Our Ref: SWW046_response070619

YSGOL GYMRAEG BRO MORGANNWG

THE ERECTION OF EXTENSIONS TO THE SCHOOL FOR A NEW SPORTS BLOCK; DESIGN AND TECHNOLOGY BLOCK; NEW RECEPTION AREA; CREATION OF NEW PLANT ROOM; NEW MUGA AND 3G ALL WEATHER PITCH; THE CREATION OF A NEW COACH DROP OFF / PICK UP AREA

1. Vale of Glamorgan Highway Authority Observation Sheet reference 2019/00280/RG3

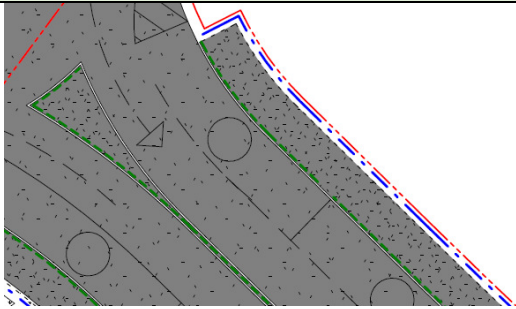
Reference No.	Issue raised	Response
1	In according to the Council’s Car Parking Standards for education establishments a requirement of 1 space per member of teaching staff, 1 space per 2 ancillary staff, 1 space per 20 six form students and 3 visitor spaces plus bus parking facilities as required. As a result of the above, the Parking Standards’ requirement for 74 teaching staff (74 spaces), 35 ancillary staff (18 spaces), 250 sixth form students (13 spaces), and visitors (3 spaces) is therefore for the provision of 108 parking spaces. The new proposal provides car parking for 122 parking	The visitor parking and disabled parking spaces are now shown on the updated drawing “ <i>ASL- 00- ZZ- DR- L- 0900 rev P17</i> ”. Extract below:

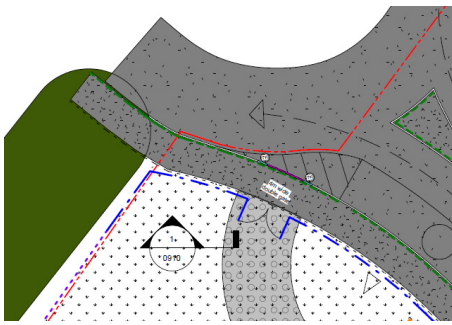
Reference No.	Issue raised	Response
	spaces which is appropriate. However, the location of the visitor and disabled parking needs to be highlighted on the general arrangement.	
2	I note from a site visit that the school currently has 3 minibuses for personal use and larger parking bays will be required to store these vehicles when the existing car park outside the existing reception is removed and suitable turning facilities	<p>The revised external works drawing “ASL- 00- ZZ- DR- L- 0900 rev P17” now shows an area for the school mini bus parking and notes to state that signage around this space is to be changed.</p> <p>Extract below:</p> 
3	The Transport Assessment indicated that the existing bus drop off bay will now be utilise for parent drop off. As a result the existing signage will need to be changed accordingly.	<p>The transport assessment has been revised (TA_V5.4 issue Full) to reflect this requirement.</p> <p>The revised external works drawing “ASL- 00- ZZ- DR- L- 0900 rev P17” now states that the existing signage is to be removed and new signage will be erected</p> <p>Extract below:</p>
